Contractor:  TIANCHEN CORP. CHINA	Project :	MKP Methanol Project			Owner :  شرکت کیمیای پارس خاورمیانه Middle East Kumiya Pars Co.
	Unit	General Technical	Phase	Detail Engineering	
	Doc. Title :	PACKAGE HAZOP			
Vendor :  新鼎信息技術(上海)有限公司 Advanced Control & Information Technologies Co., Ltd.	Owner No.	MKP-11-DE-9000-SF-RPT-001B			Rev. : 0
	Contr. No.:	MKP-11-DE-9000-SA01-RPT-001B			
	Vendor No.	16E2416A			Page : 1 of 25

PACKAGE HAZOP

Node 2010

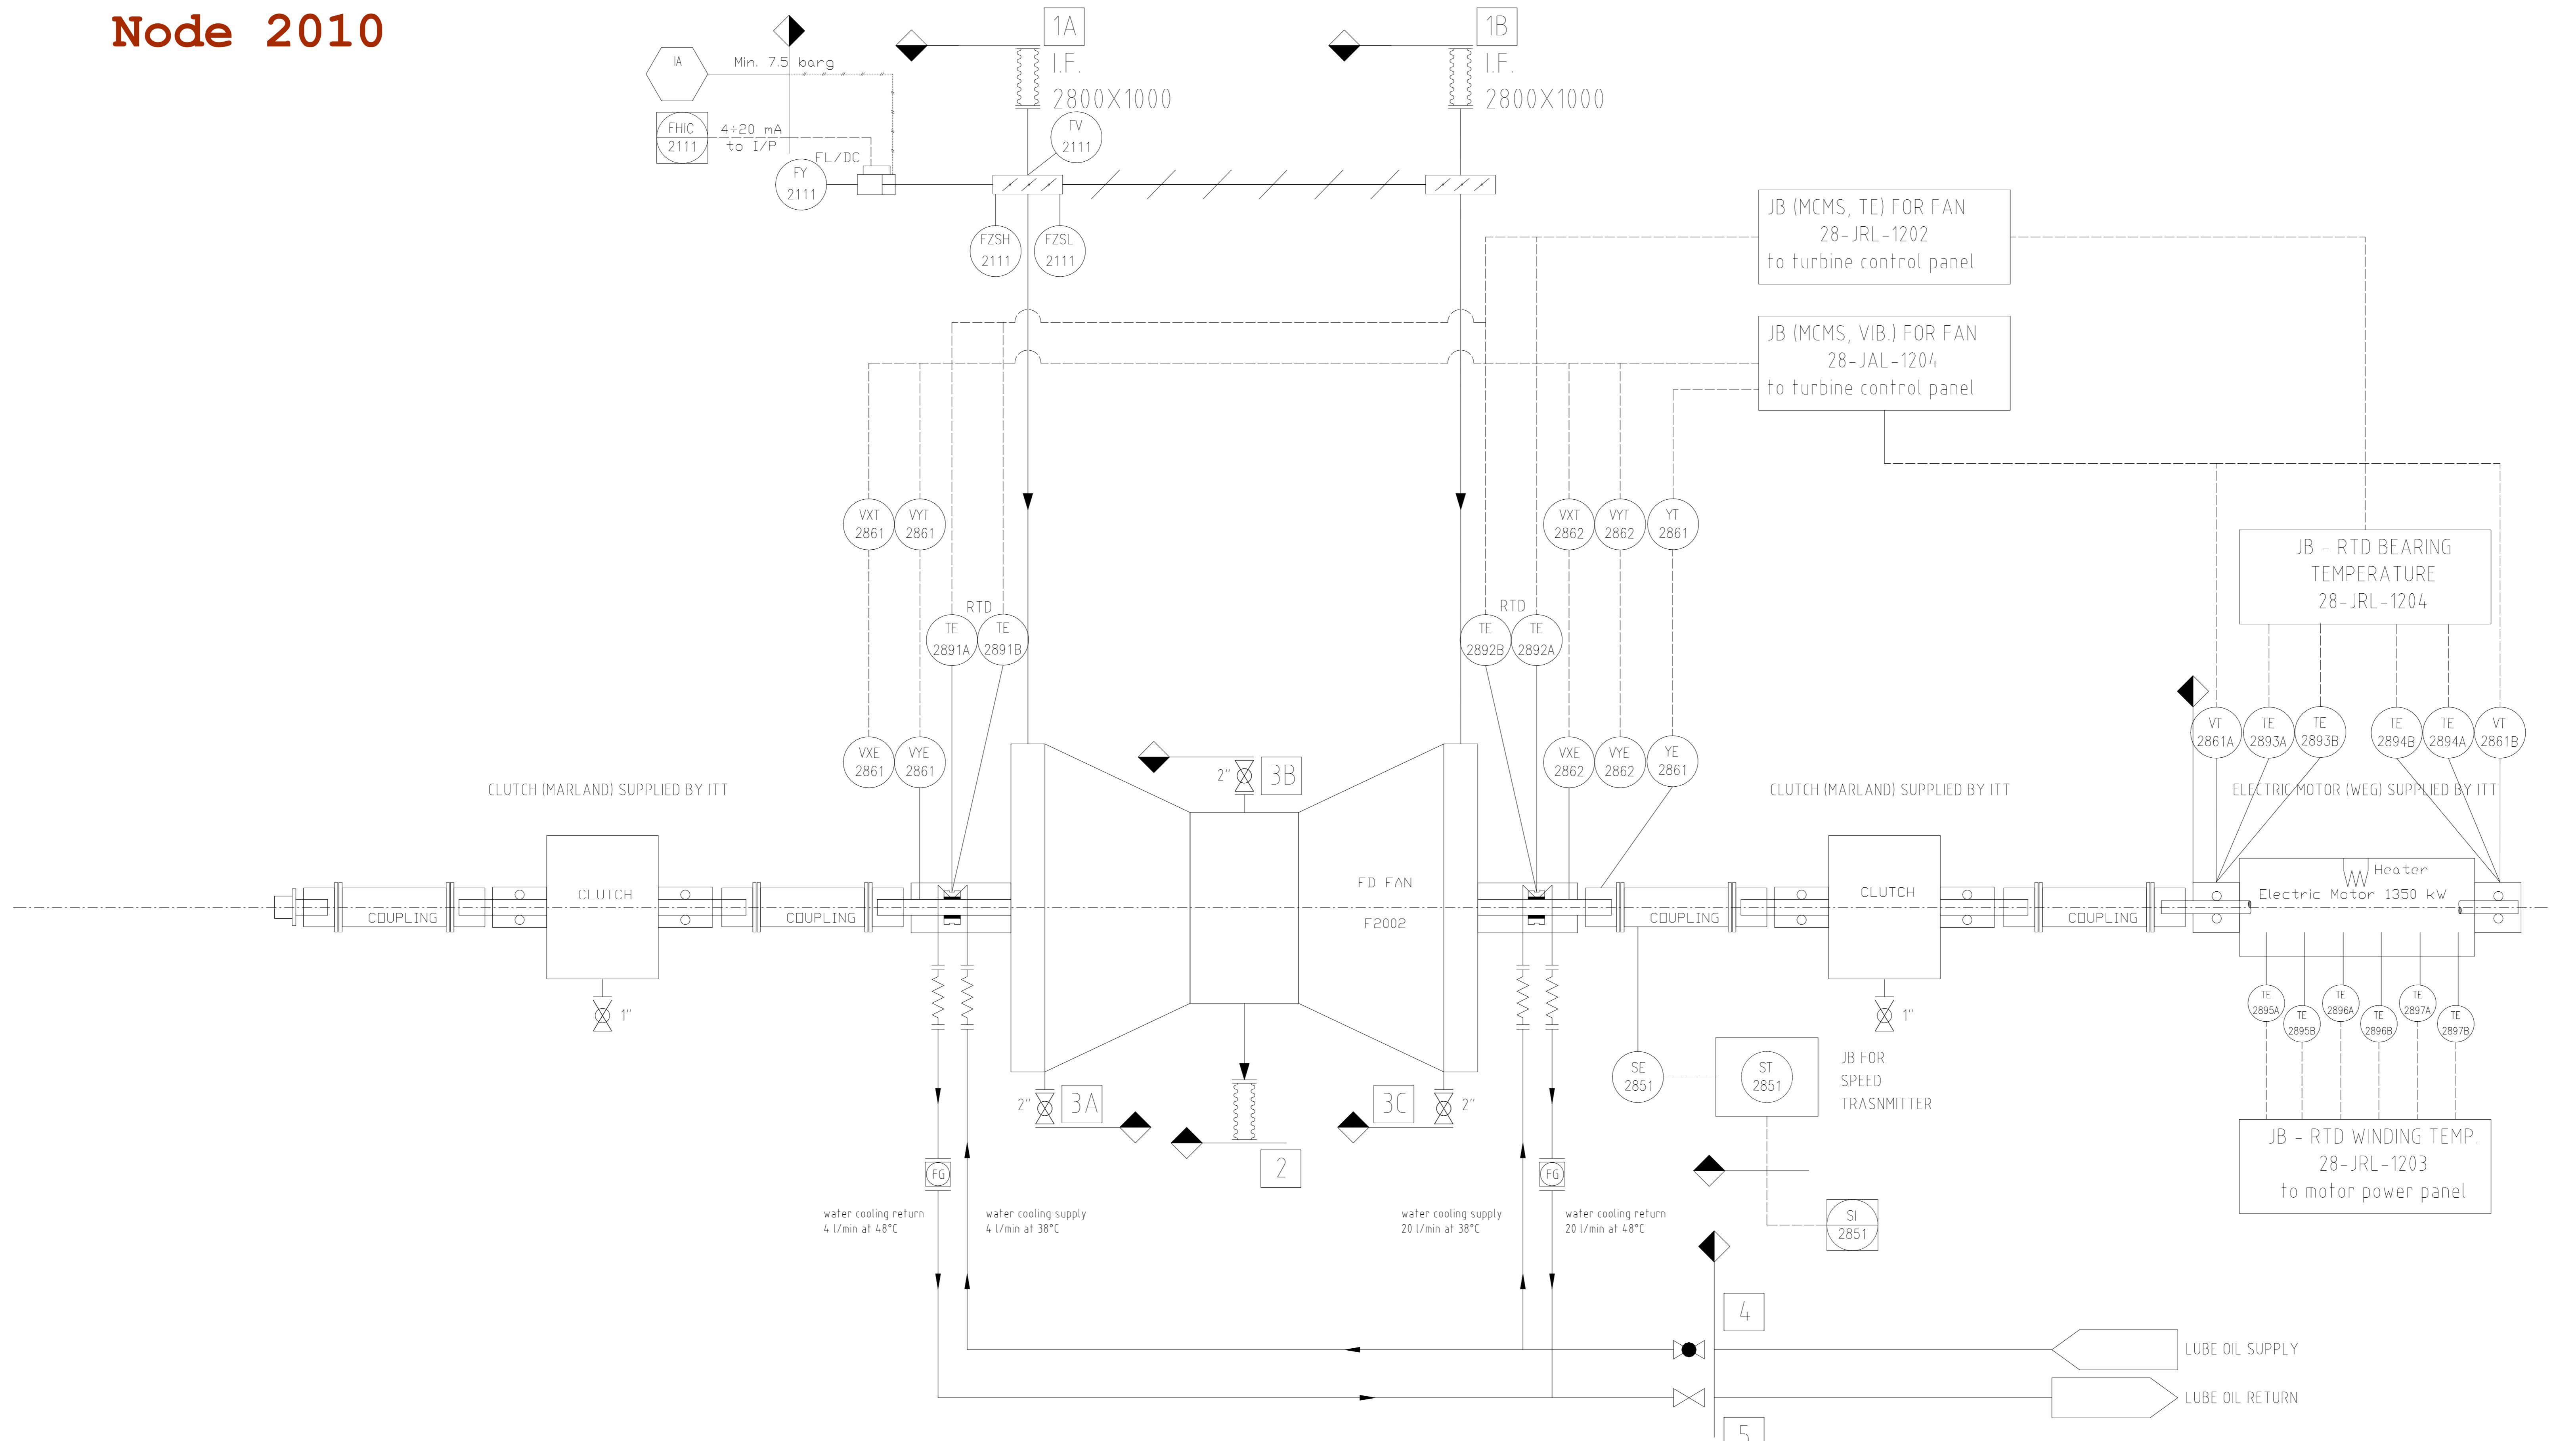
2010.7	1	Add desuperheater on the LP steam header.	Y			TCC
2010.8	1	1.PDI-2861 add high d/p alarm. 2.Add TI-2862 low temperature alarm.	Y			ITT
2010.9	2	Add blind flange after the drain valve.	Y			ITT
2010.13		Due to incomplete data of P&ID for MF-2002, it will be checked later. TCC shall be issued completed P&ID like other MV motors of plant and consider auto start and relevant signals for it.	Y			ITT/TCC
2010.14	2	Add PICA-2163 high pressure alarm.	Y			ITT/TCC
7007.1	3	Add high pressure alarm and high high pressure trip at turbine inlet utilizing inlet PT to send signal to CW-Hydro PLC.	Y			CW-Hydro
7007.2	3	Add high pressure alarm and automatic stop auxiliary oil pump.	Y			CW-Hydro

. 7	high temperature(outlet turbine)	1 No load operation.	High temperature in exhaust of turbine.	TI-2852 high temperature alarm and high high temperature trip.	2	2	1	N	Add desuperheater on the LP steam header.
. 8	low temperature(Lube oil)	1.1.External low temperature. 2.Cooling water overflow.	1.Viscosity of lube oil increase and cause shaft to wear out and damage turbine and ID fan. 2.Decrease the performance of lube oil pump and decrease the oil supply. 3.Increase d/p of the filter.	1.Lube oil heater will switch on when external low temperature. 2.PDI-2861 d/p indicator for filter.	1	4	1	N	1.PDI-2861 add high d/p alarm. 2.Add TI-2862 low temperature alarm.
